Item #
MCPB 03-01-07

MEMORANDUM

REVIEW TYPE: **Site Plan Review**
CASE #: **820070040**
PROJECT NAME: **Sovereign Bank**

APPLICANT: Henderson Corner at 355, LLC
FILING DATE: 9/15/06
HEARING DATE: March 1, 2007

Schematic Architectural Elevations showing Character of Tower Gateway Element

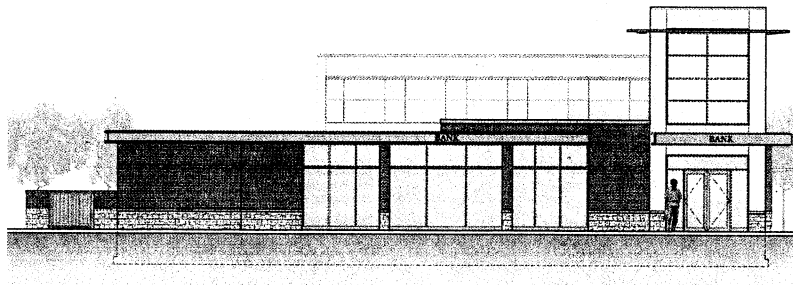
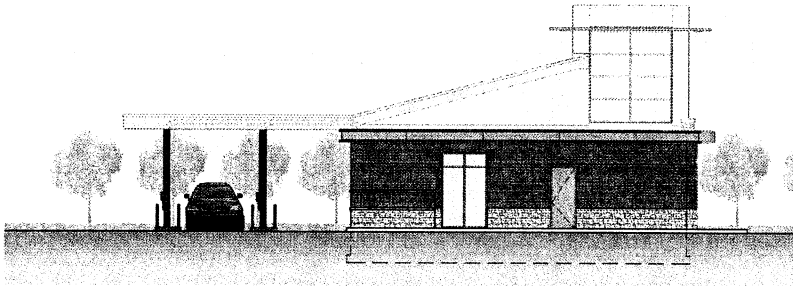
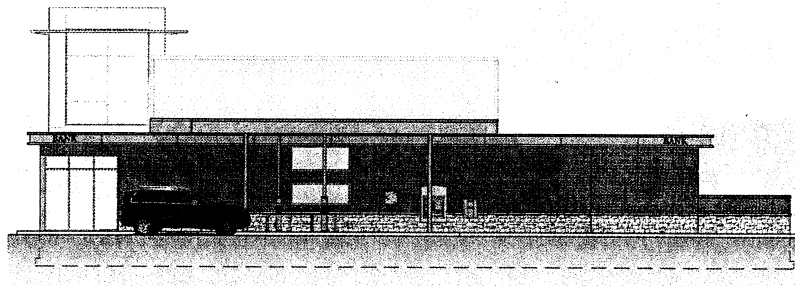
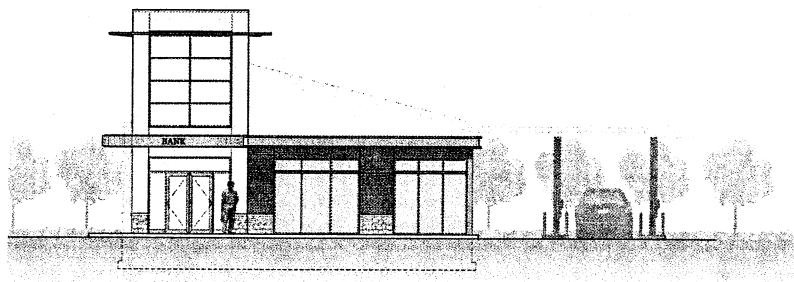
The Master Plan also recommends that the development of this site “should recognize its gateway location through the placement of the buildings, landscaping and berming, and building design.” (page 84) To this end the applicant commits to providing a building design that includes a vertical gateway feature similar to the tower design indicated below.

Applicant will provide on the northeast corner of the bank building a vertical building element, similar to the design illustrated in the site plans stamped by the M-NCPPC on February 12, 2007.
